DOMINION ENERGY KEWAUNEE, INC.
KEWAUNEE POWER STATION
SUPPLEMENT AND RESPONSE TO REQUEST FOR ADDITIONAL INFORMATION:
LICENSE AMENDMENT REQUEST 236, AUTOMATIC OPERATION OF
TRANSFORMER LOAD TAP CHANGERS (TAC NO. ME4011)

**RESPONSE TO REQUEST FOR ADDITIONAL INFORMATION:
LICENSE AMENDMENT REQUEST 236
AUTOMATIC OPERATION OF TRANSFORMER LOAD TAP CHANGERS**

Figure 1

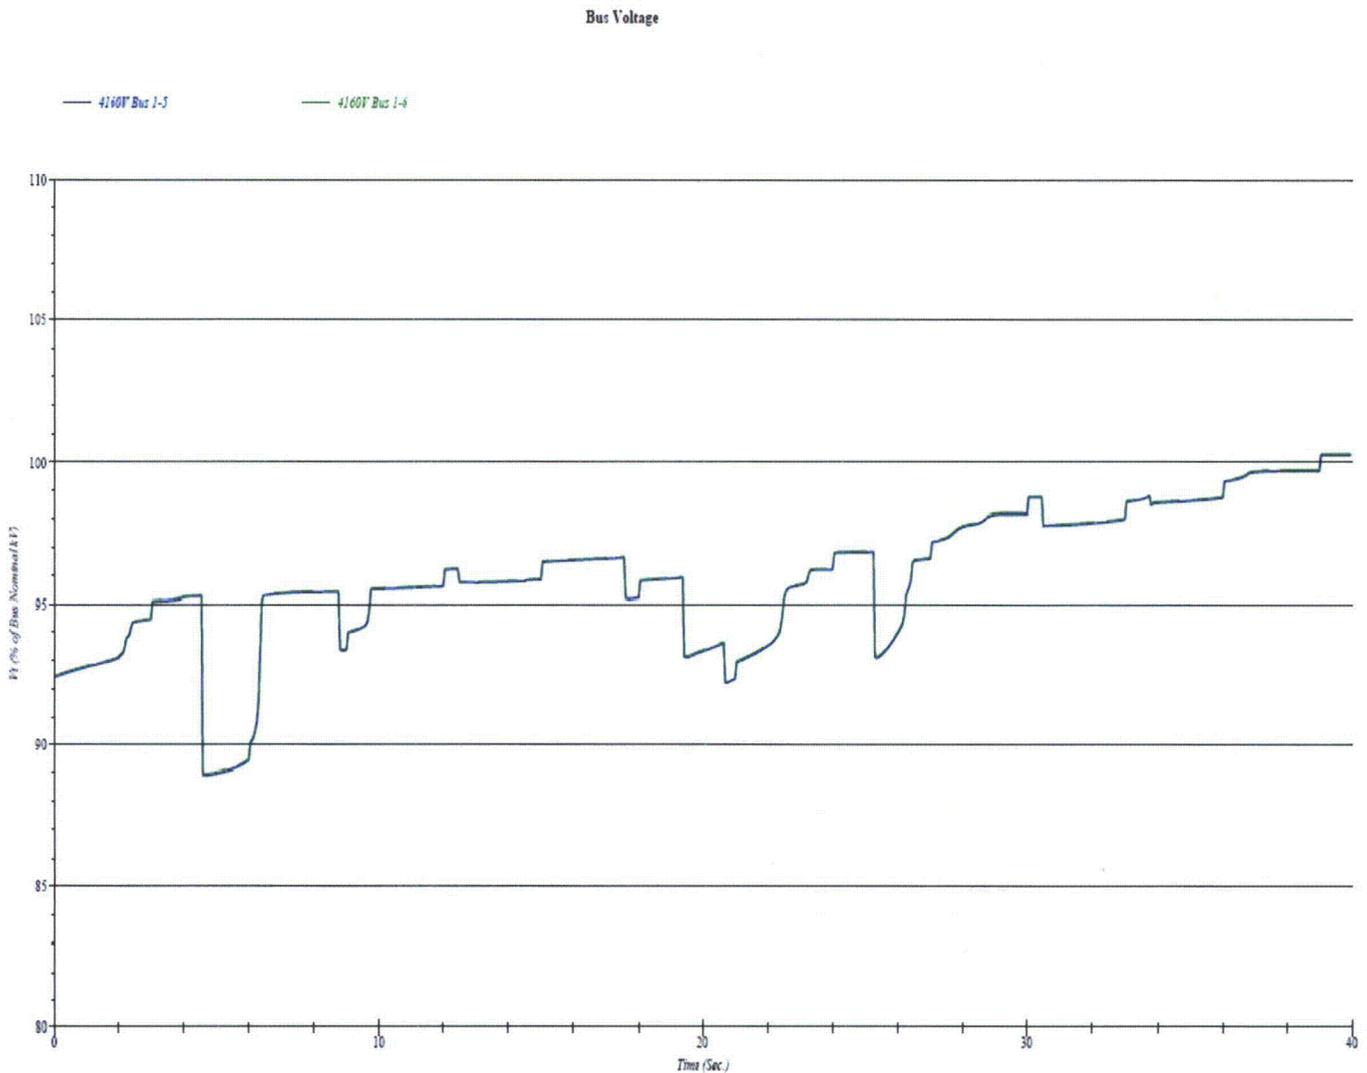
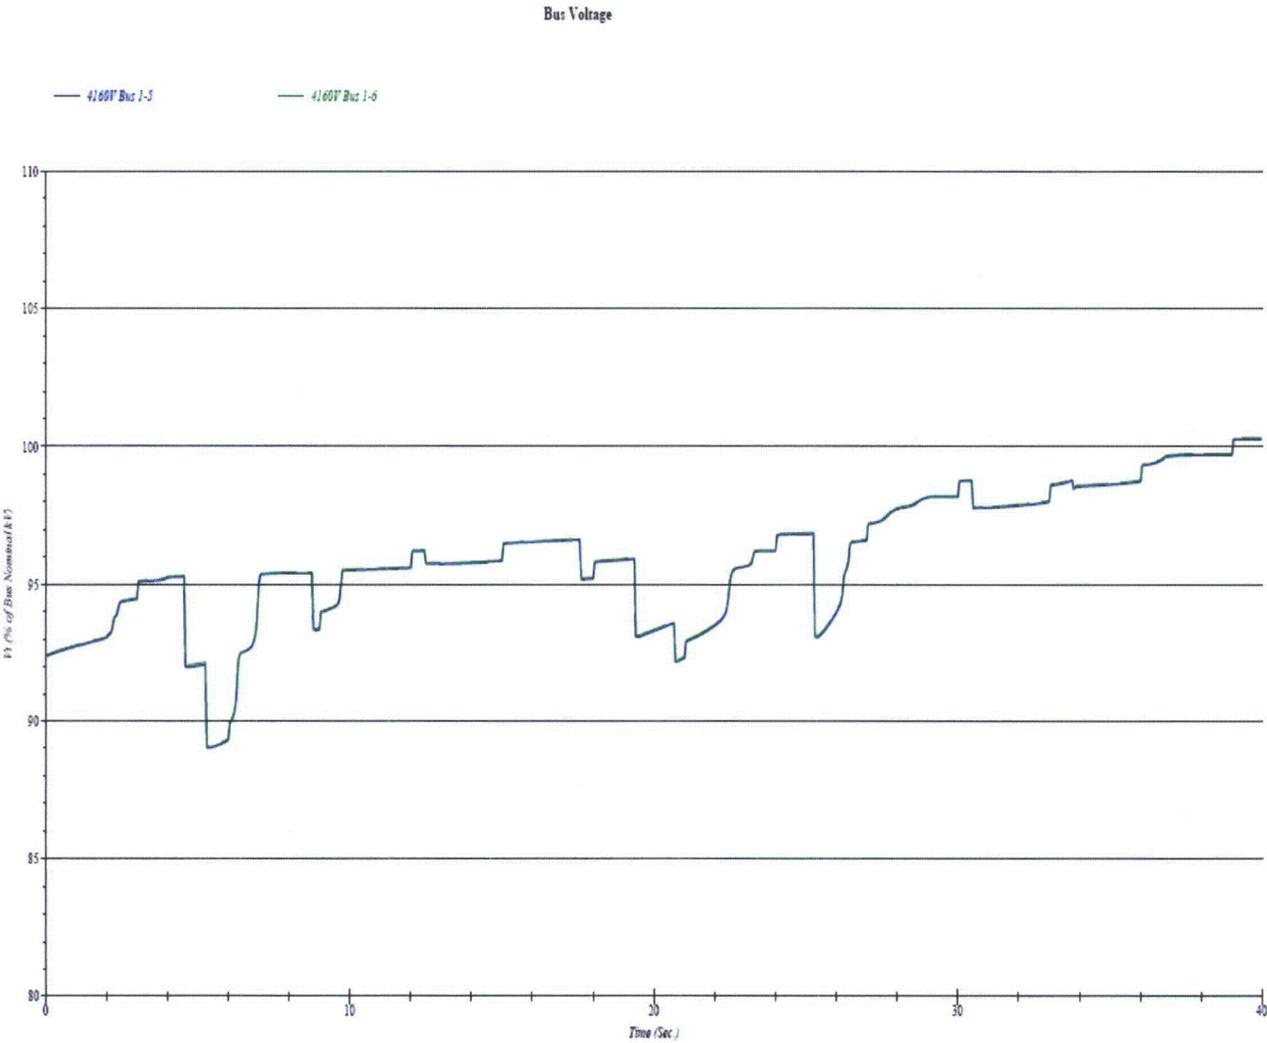
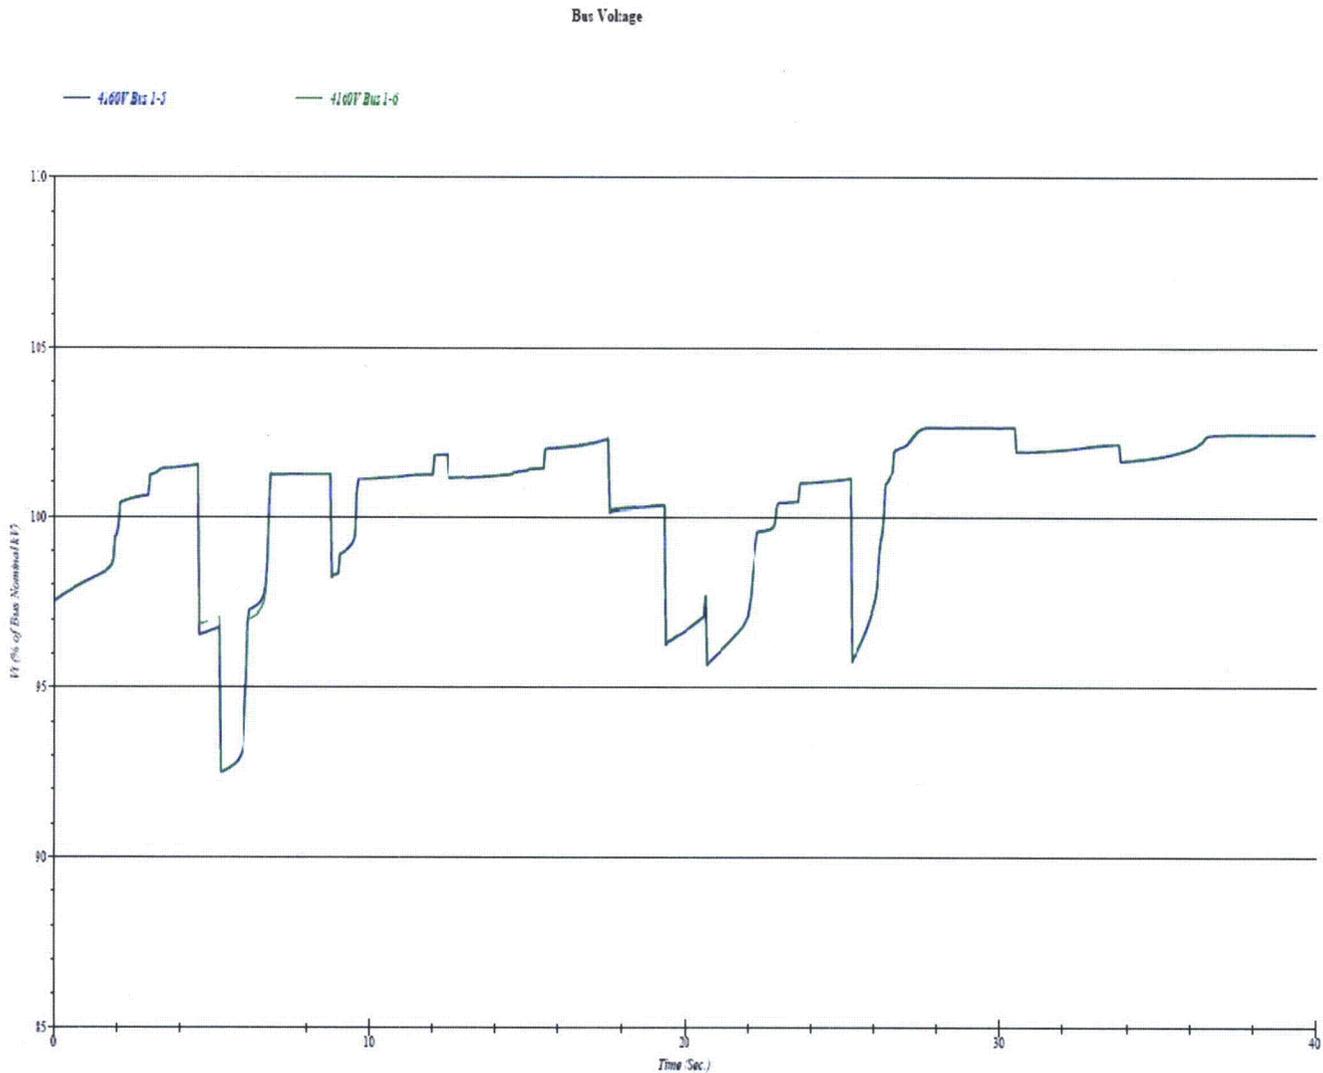
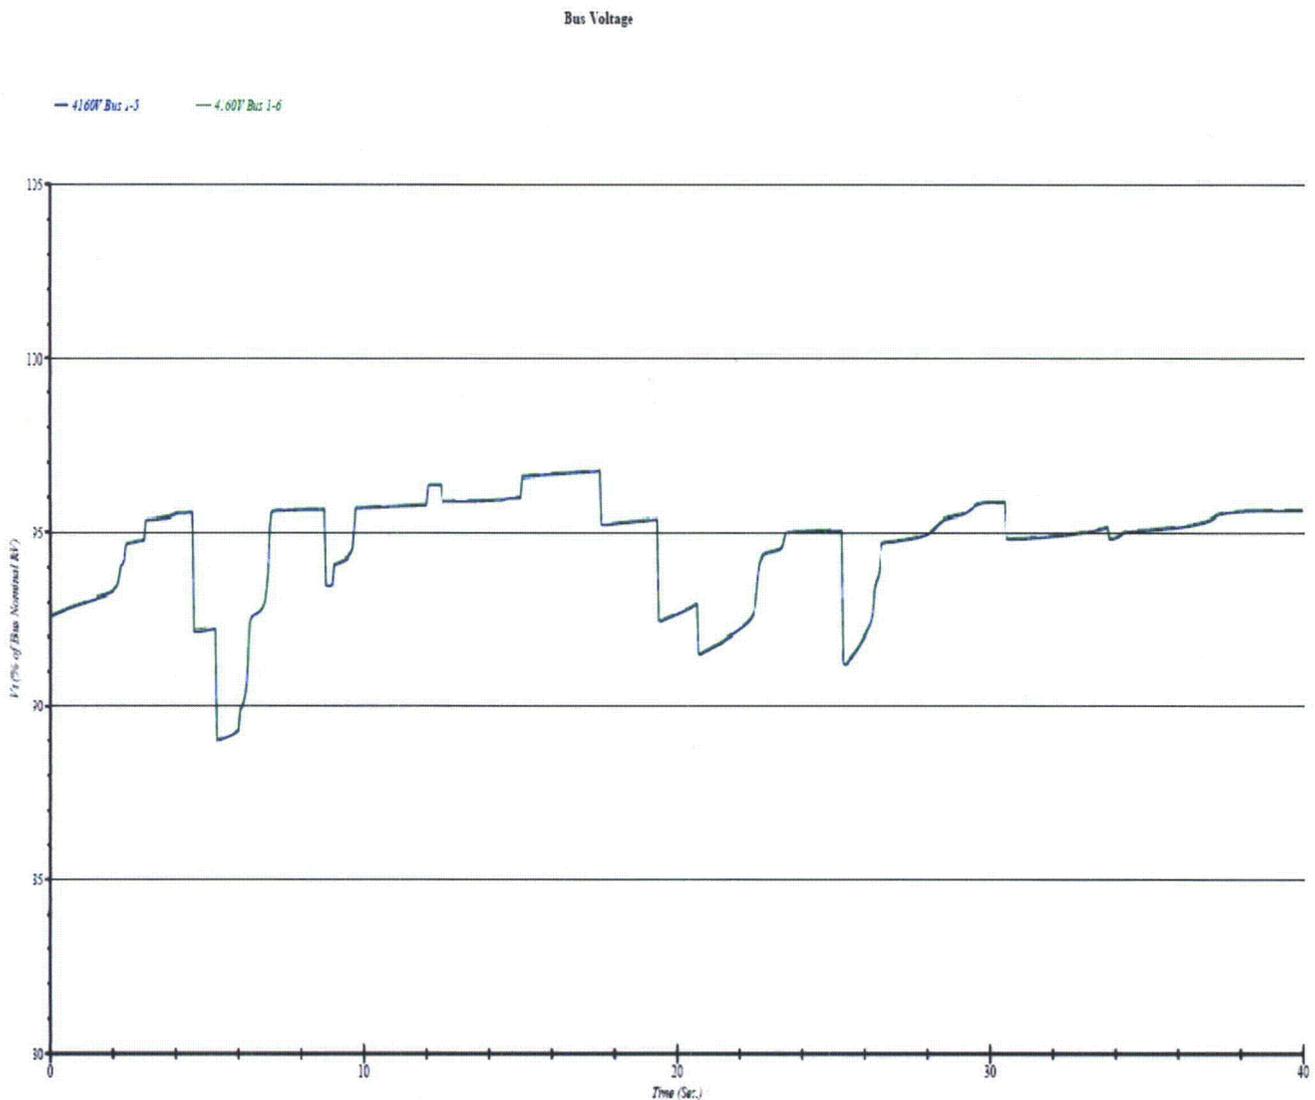
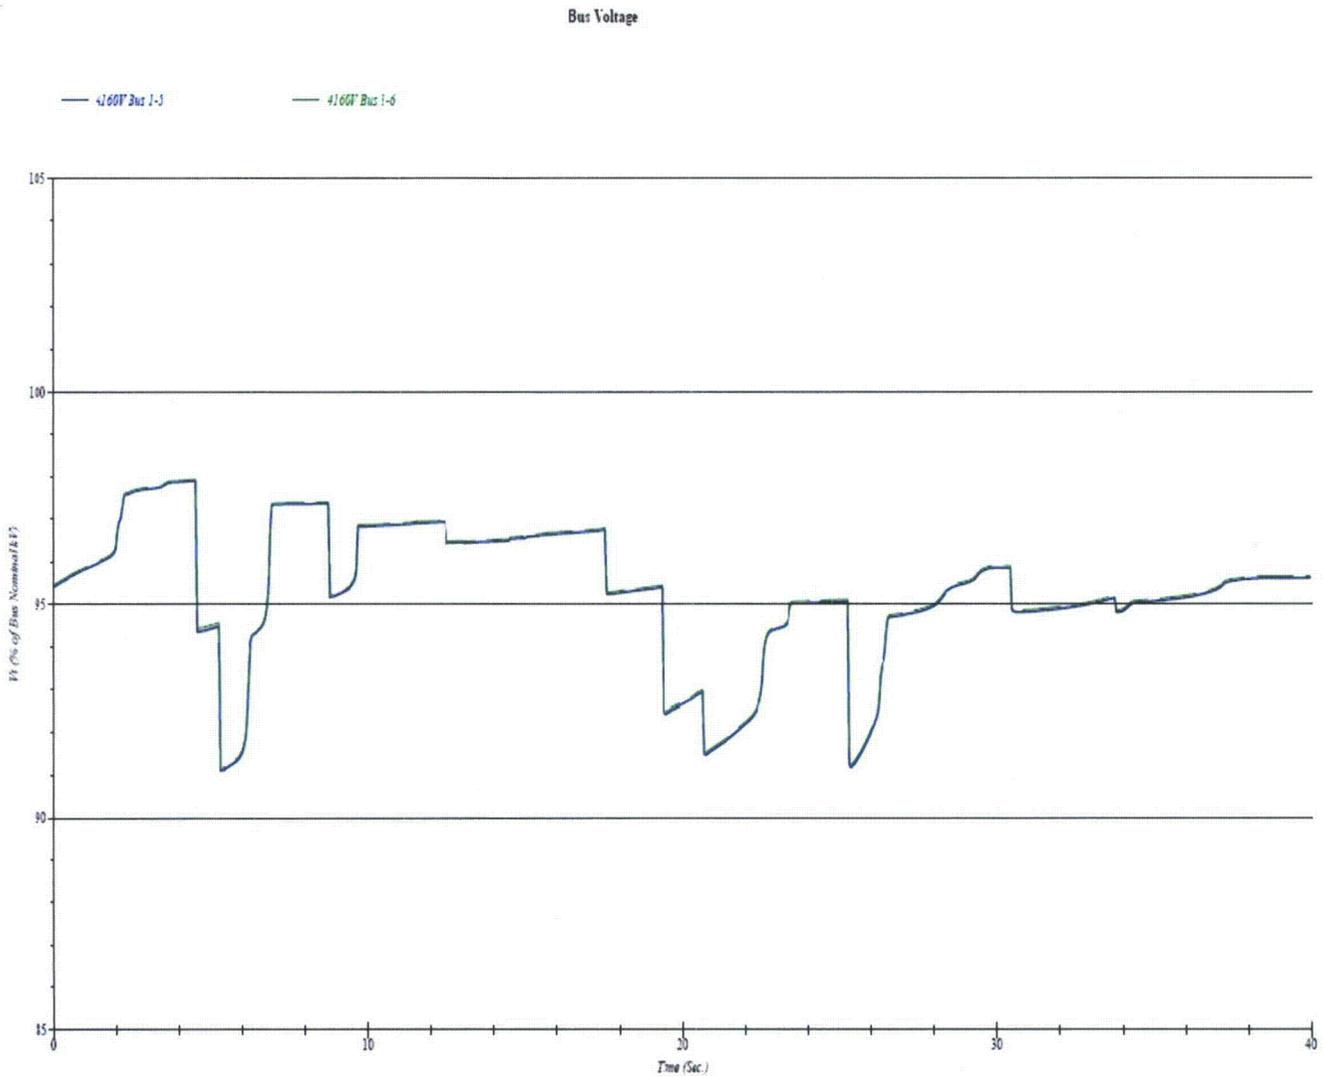
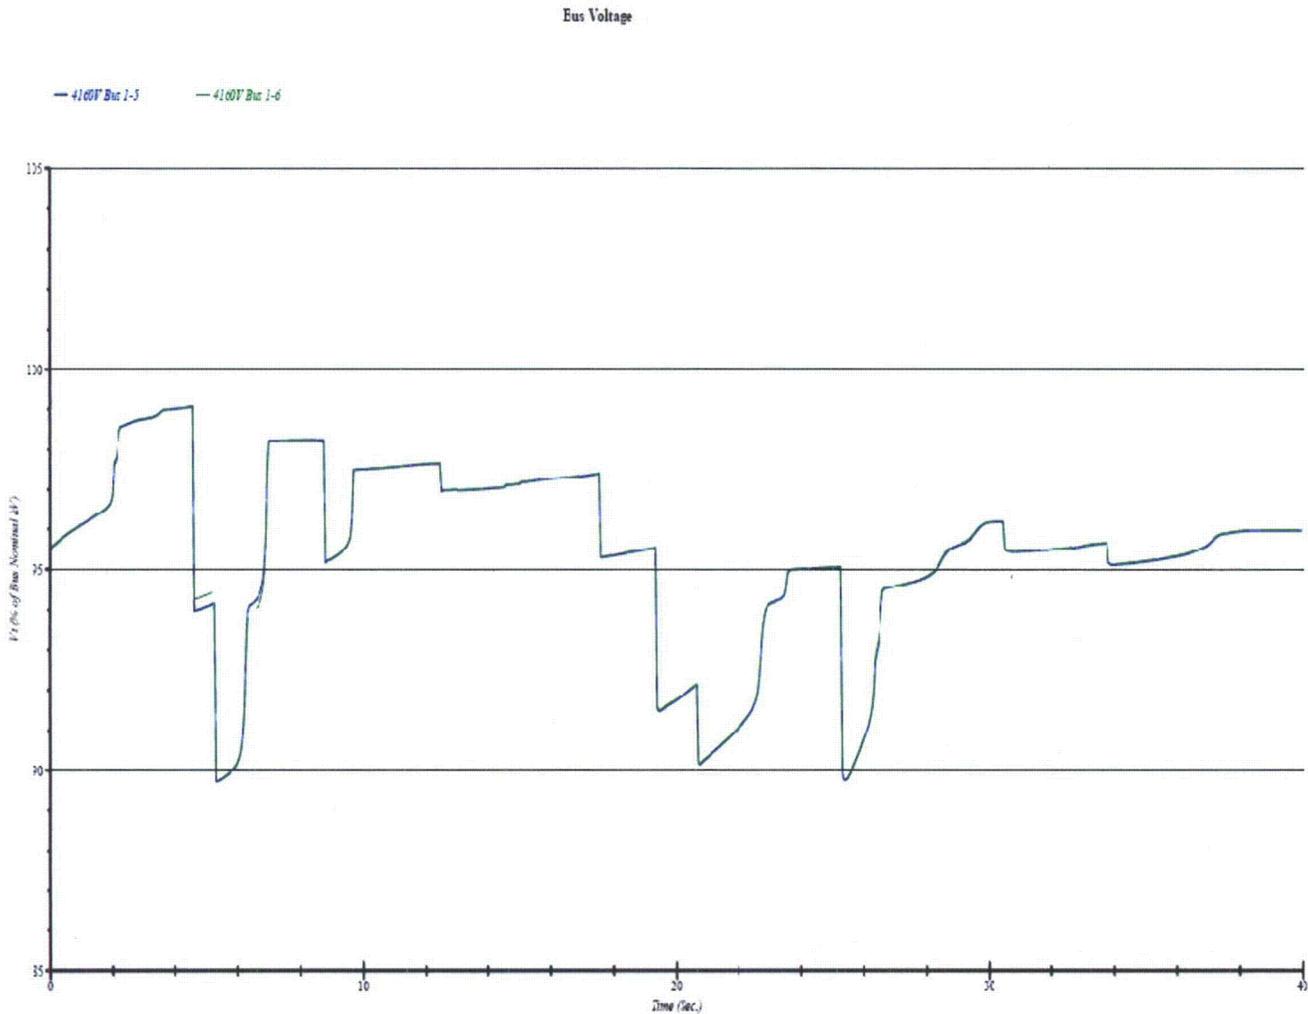
Bus 1-5 is normally supplied from the TAT and Bus 1-6 is normally supplied from the RAT. Thus, no bus transfer is required for the engineered safety features in the event of a unit trip. The plant was designed with an automatic bus transfer feature. Verify that a single failure of the bus transfer scheme will not result in transfer of the Busses 1-5 and 1-6 to a single source of offsite source during a design basis event.

ETAP runs were performed to verify the initial tap position (post event) based on the pre-event tap position (prior to generator trip and SI sequence initiation); and, to establish that the degraded voltage relaying (DVR) would not actuate. Based on analyses performed by American Transmission Company (ATC – transmission operator for KPS), if KPS loses both of its 345kV lines or both T10 and T20 345/138kV transformers (related to the two 345kV switchyard lines); or, if both Point Beach Nuclear Power (PBNP) units are unavailable; or, if Q303 (345kV) and F84 (138kV) transmission lines are both out of service, then it is possible that the maximum change in switchyard voltage due to a KPS unit trip would be from 1.82% to 2.76%. Therefore, for the above

Absence of these worst case conditions would result in a much smaller resultant voltage change. The ATC analyses show that other possible limiting switchyard configurations would result in a maximum voltage drop of 1.465% or less. DEK plans to request that ATC provide a programmed load/voltage forecast warning indication to KPS upon the system forecasting a 1.46% or larger drop in voltage at KPS (due to KPS unit trip). In the event that a larger than 1.46% drop in voltage is forecasted, KPS operators have the capability to manually transfer Buses 1-3 and/or 1-4 to the RAT. This anticipatory transfer would cause the upstream RAT supply transformer (RST) LTC to raise taps and account for the additional Bus 1-3 and/or Bus 1-4 load prior to the trip and thereby decrease the 4kV voltage drop associated with the non-safety related bus transfer at the time of a unit trip. Thus, DVR actuation would not be expected to occur, and the offsite power source (RAT supply) would be maintained.

Voltage profile graphs of the associated ETAP analyses results are provided (for information) in Figures 1 through 7 below. These graphs show that voltage does not decrease below 95% of nominal bus voltage for more than 6 seconds. Although the DVRs themselves actuate, their associated time delay relays do not time out. Thus, no bus stripping signal is initiated and offsite power remains available.
